Reference: 12S1395000

28 November 2014

**RE: CENTRAL PARK, BROADWAY – BLOCK 1 STATE SIGNIFICANT
DEVELOPMENT APPLICATION FOR A MIXED USE BUILDING (SSD 6554)
AND MODIFICATION TO THE PROJECT APPROVAL FOR COMMERCIAL
DEVELOPMENT ON BLOCKS 1 AND 4N (MP08_0253 MOD 5)**

Figure 1: Approved Concept Plan (MP 06_0171 (MOD 2))

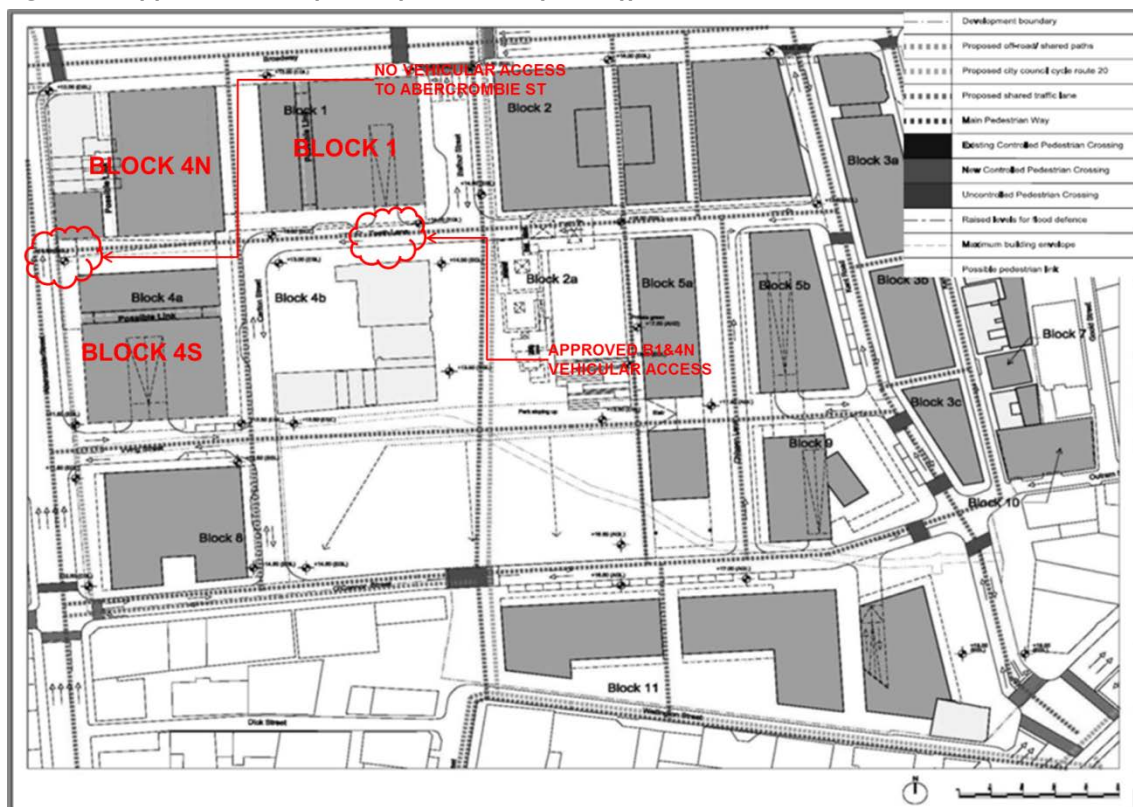
In addition, in their submission the City of Sydney contended that the vehicular access into Block 1 basement car park should be from Abercrombie Street and for the “secondary” access from Central Park Avenue to be deleted.

The City of Sydney submission incorrectly states that:

“The approved Concept Plan and Project Application (subject to a concurrent modification as present) provide vehicle access for Blocks 1 and 4N to/from Abercrombie Street into a combined 4 level basement.

The proposed development maintains the combined basements but introduces a new secondary entry and exit from Central Park Avenue at the south-western corner of the development”.

The above statement is incorrect. The approved Concept Plan does not include a vehicular access off Abercrombie Street. Developments within Blocks 1 and 4 have always been approved with a single access off Central Park Avenue. Reference to this as secondary access is not correct.

The concept plan as approved in MP 06_0171 (MOD 2) is re-produced below as Figure 1 (this figure was also included in the transport report that accompanied the SSDA).
